ADDENDUM NO. 2

COUNTY ROAD 17 (Bakerstand Road) - RESURFACING

STATE ROUTE 242 TO FRANKLIN VILLAGE LINE

ADDENDUM DATE: 16 MAY 2023

TYP-01

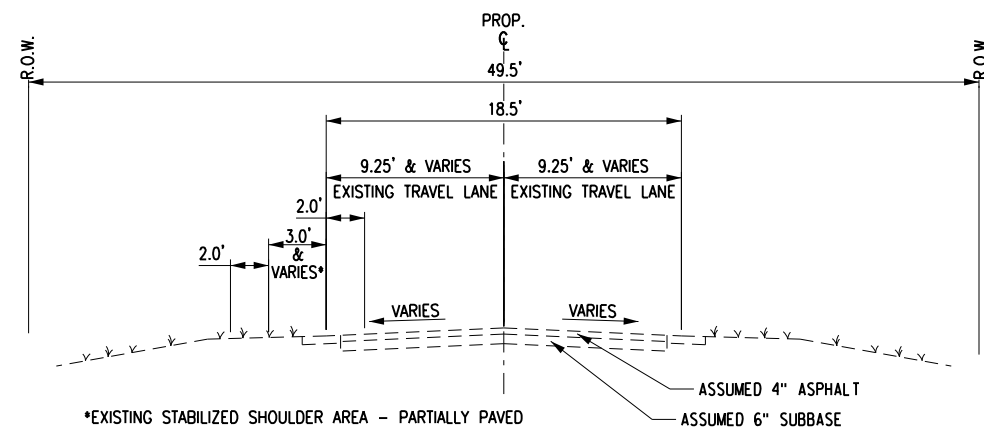
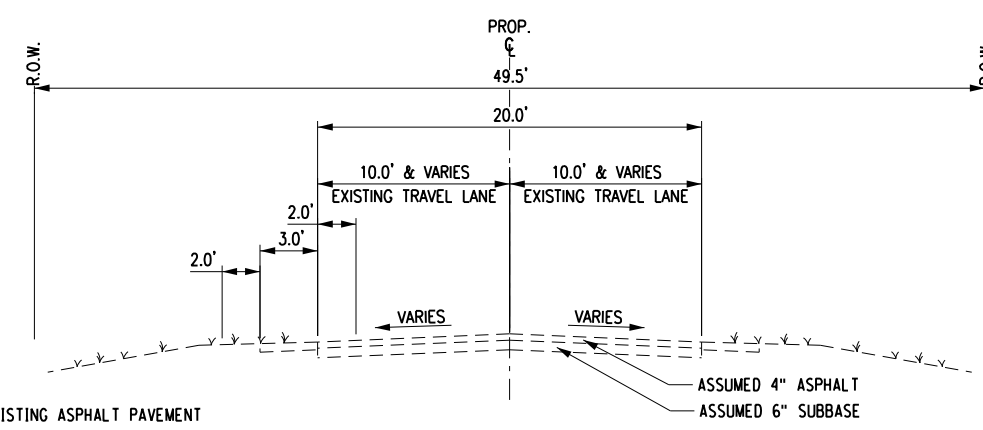
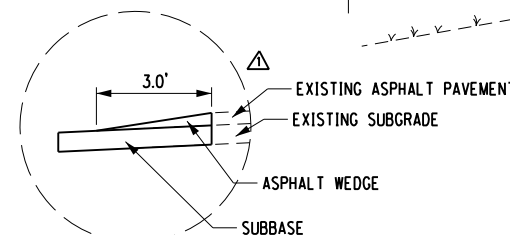
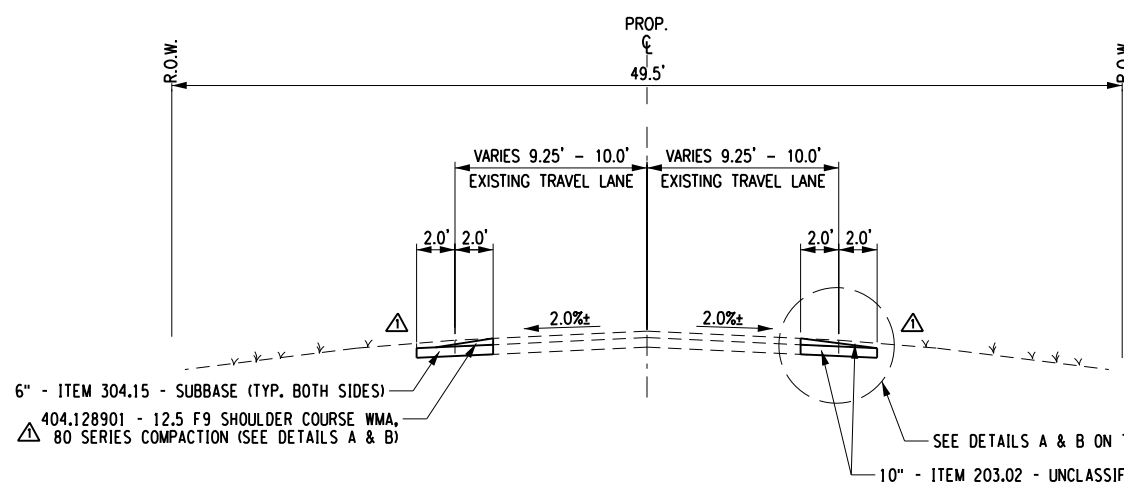
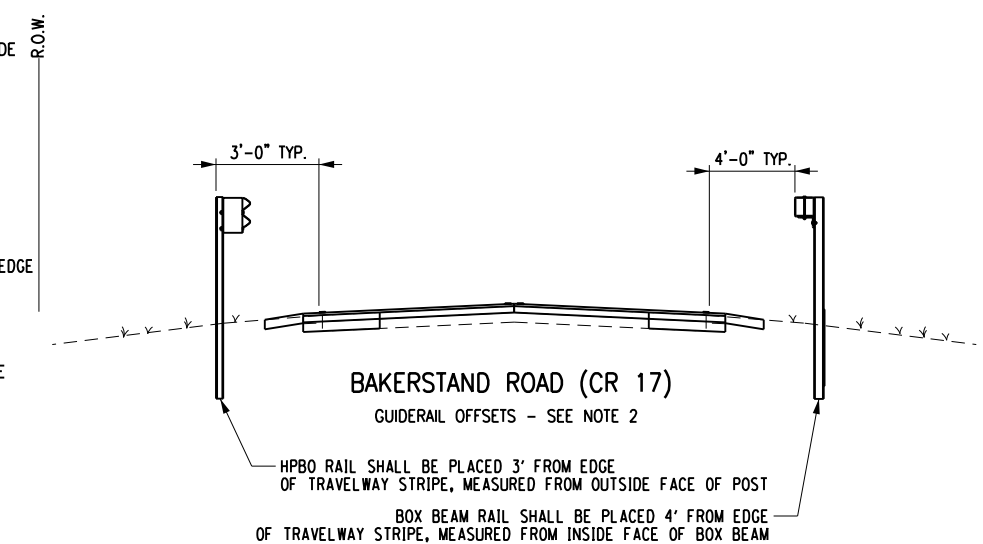
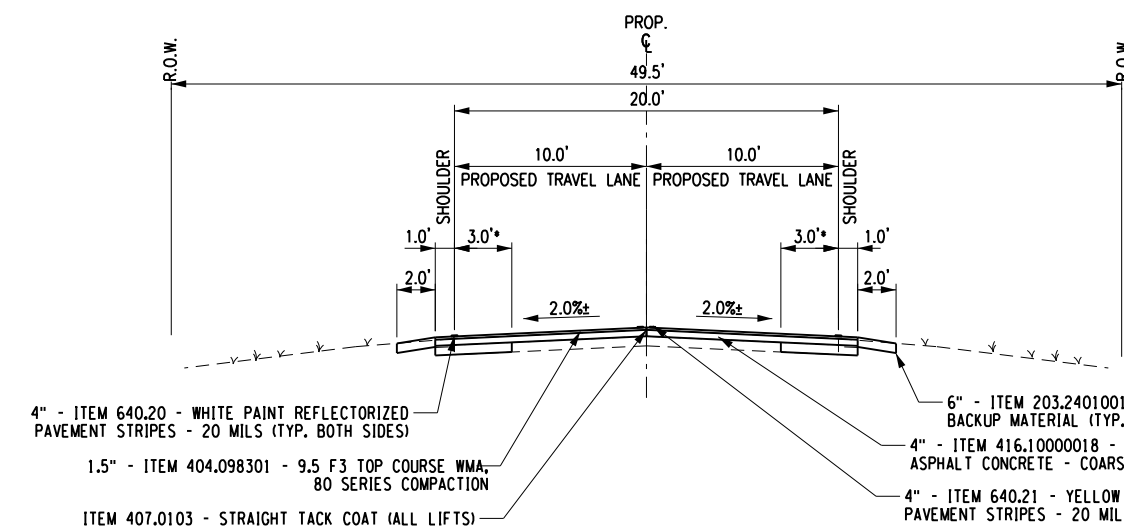
Plans: Sheet 6 superseded by Sheet 6 A1 of 33: TYP-01 changes made to typical sections, addition of details showing asphalt wedge.
